# Access Compliance Report

## Public Rights-of-Way

### (Curb Ramps)

Intersection ID: 29696	Main Street: CAMERON_CREEK_DR	Cross Street: KENWOOD_TERRACE_DR	Location: S
ADA ID: AD8910A47943	Ramp Type: PerpDiag	Initial Pass/Fail: Fail	Overall Compliance: No
Severity Score: 17.5			
Codes/Mitigation Info/Possible Solution		Field Measurements/Component Compliance

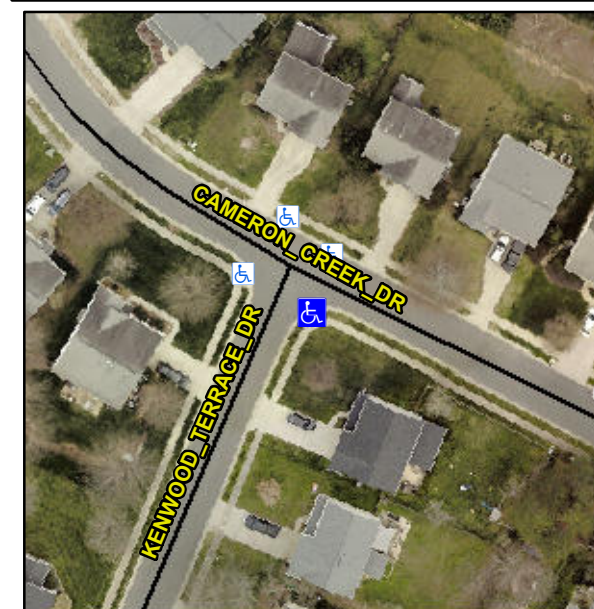
Compliance	Description	Data	Compliance	Description	Data
N/A	Ramp Length (in)	46.0	Yes	Ramp Slope (%)	7.7
No	Ramp Width (in)	32.0	Yes	Ramp XSlope (%)	1.7
N/A	Flare Type LT	N/A	N/A	Flare Type RT	N/A
N/A	Flare Slope LT (%)	N/A	N/A	Flare Slope RT (%)	N/A
N/A	Flare Traversable LT?	N/A	N/A	Flare Traversable RT?	N/A
N/A	Landing Length (in)	N/A	N/A	DWS Provided?	N/A
N/A	Landing Width (in)	N/A	N/A	DWS Contrast?	N/A
N/A	Landing Slope (%)	N/A	N/A	DWS Length (in)	N/A
N/A	Landing X Slope (%)	N/A	N/A	DWS Full Width?	N/A
N/A	Landing Curb? (Y/N)	N/A	N/A	DWS Offset (in)	N/A
N/A	Shared Landing?	N/A			
N/A	Gutter Ponding?	N/A	N/A	Gutter Slope (%)	N/A
N/A	Gutter Lip Ht (in)	N/A	N/A	Gutter X Slope (%)	N/A
N/A	Painted X Walk1?	No	N/A	Painted X Walk2?	No
	X Walk 1 Direction	To NE		X Walk 2 Direction	To NW
N/A	X Walk 1 Width (in)	N/A	N/A	X Walk 2 Width (in)	N/A
	X Walk 1 Slope (%)	3.7		X Walk 2 Slope (%)	2.6
	X Walk 1 X Slope (%)	2.6		X Walk 2 X Slope (%)	0.9

N/A	Ramp inside XWalk1?	N/A	N/A	Ramp inside XWalk2?	N/A
	Road Slope (%)	0.1	N/A	Clear Space?	N/A
	Road X Slope (%)	3.4	N/A	Clear Space to XWalk (in)	N/A
N/A	Any Obstructions?	N/A	N/A	Storm Grate/Utility Hazard?	N/A
	Obstruction Type			Storm Grate/Utility Type	
		N/A			N/A
			Yes	Surface Condition? (G/P)	Good

**Remove & Replace Curb Ramp With Two New Directional Ramps or Equivalent.**

**R304.5.1**
